CONNECTION ASSESSMENT & APPROVAL PROCESS

*Project: MacKay TS
Installation of a Generation Rejection Scheme*

CAA ID No. 2002-EX074

MACKAY TS - Install Generation Rejection Scheme

DIAGRAM 1

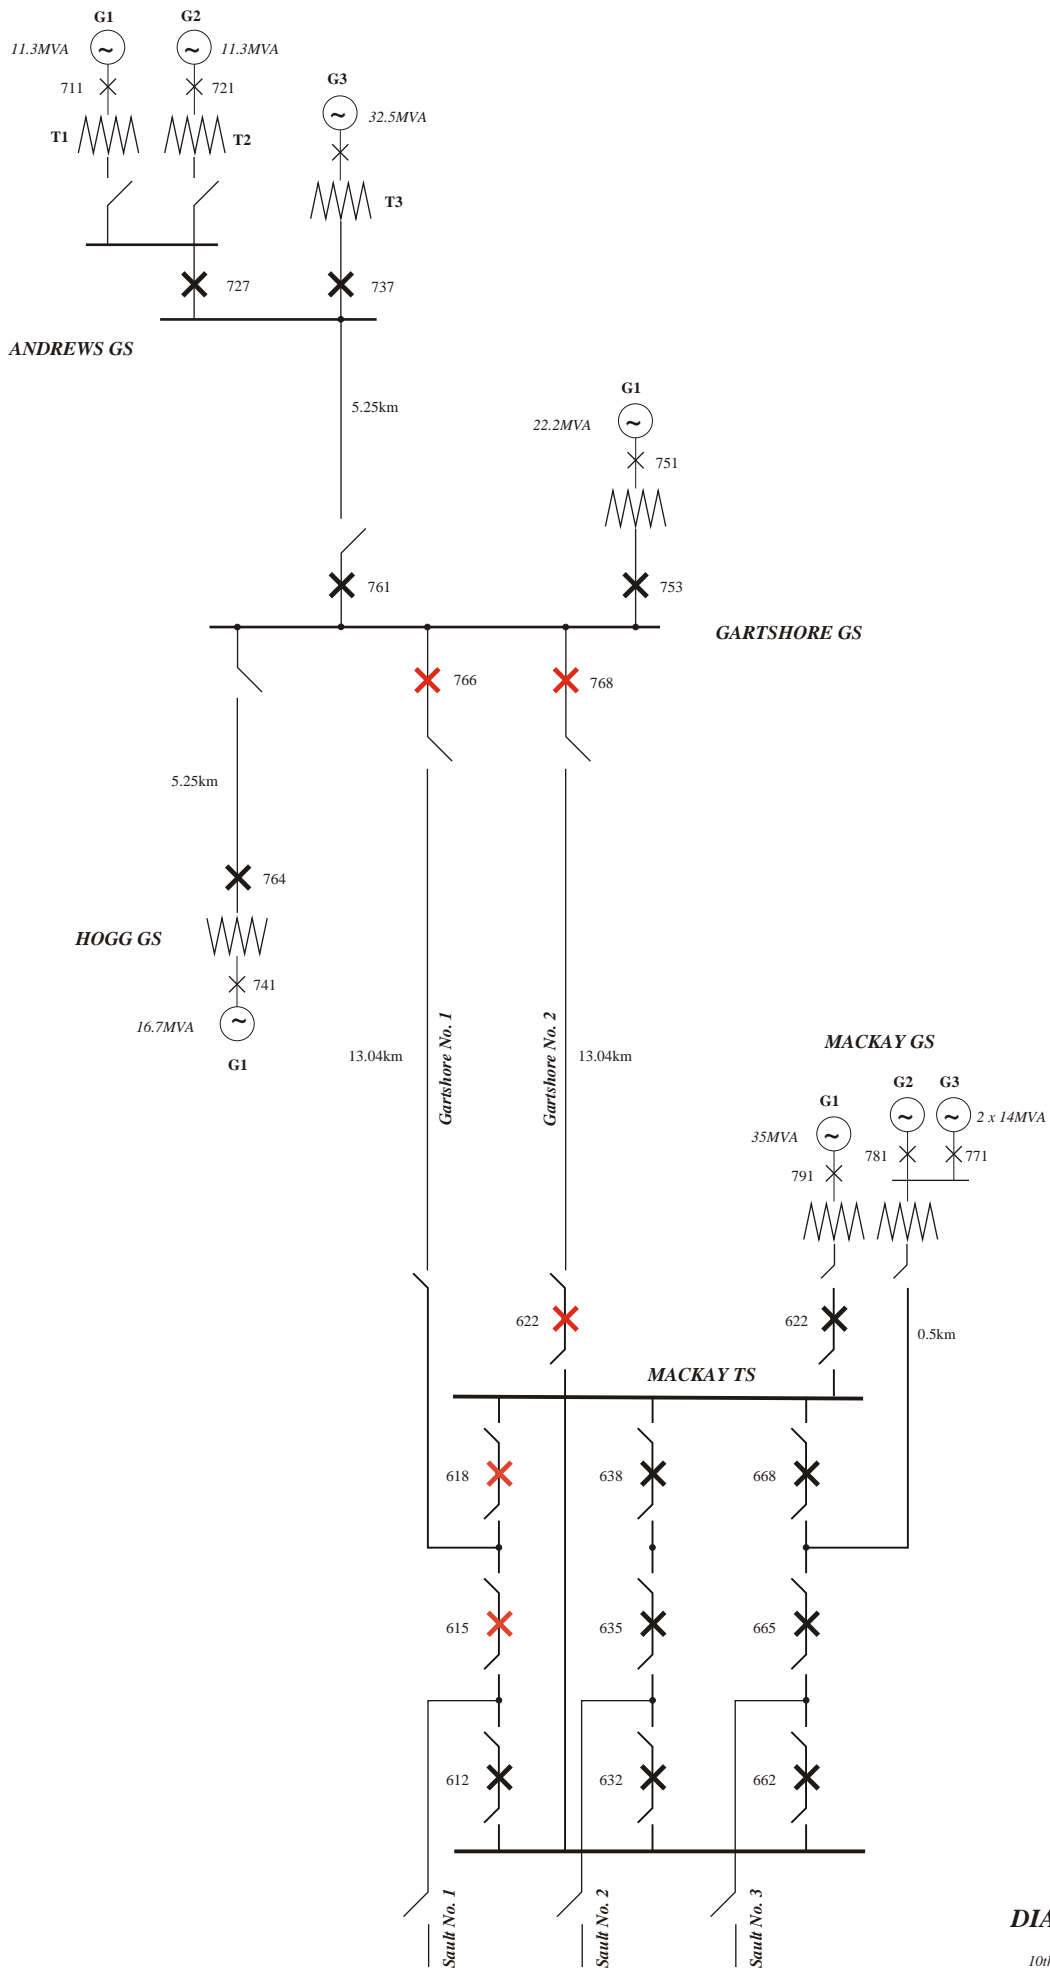
The following four generating stations are presently in operation on the Montreal River and incorporated via the 115kV system into MacKay TS, as shown in Diagram 1:

MacKay GS	63.0MVA	incorporated directly into MacKay TS
Hogg GS	16.7MVA	} Σ 94MVA ~ incorporated via the two Gartshore 115kV circuits
Gartshore GS	22.2MVA, &	
Andrews GS	55.1MVA.

The two Gartshore circuits, Nos 1 & 2, have continuous summertime ratings of approximately 100MVA and 60MVA, respectively. However, since the combined capacity of the generating facilities incorporated via these two circuits totals approximately 94MVA, a contingency involving the Gartshore No. 1 circuit would result in the continuous rating of the lower-rated No. 2 circuit being exceeded.

DIAGRAM 3

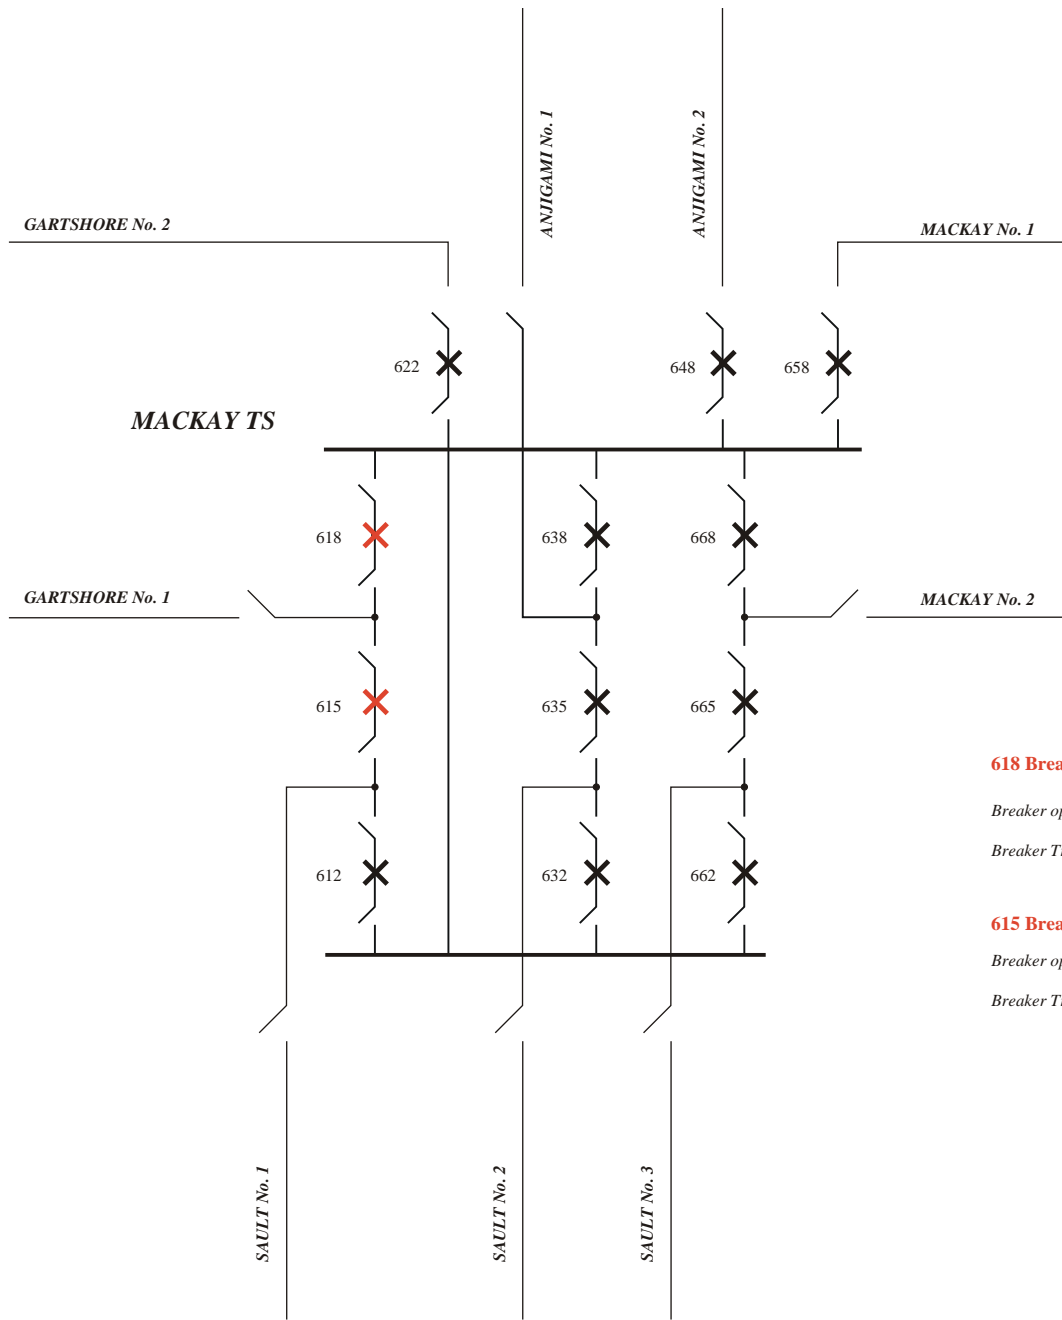
Diagrams 3 & 4 provide the details of the ‘contingency detection facilities’ that are to be installed at Gartshore GS and MacKay TS, respectively. These facilities are to be duplicated.

- The G/R Scheme must be fully duplicated (this includes contacts, relays, communications and batteries).
 - If latching relays are used, then since their status is to be monitored and any discrepancy will be alarmed, these do not need to be duplicated.
 - However, if PLCs are used, these must be duplicated with discrepancy monitoring installed on the PLCs.
- The status of the latching relay, or PLCs is to be telemetered to the IMO.
- The contingency detection facilities must use contacts from the breaker trip modules (to enhance the speed of operation of the generation rejection) as well as from the breaker pallet switches.
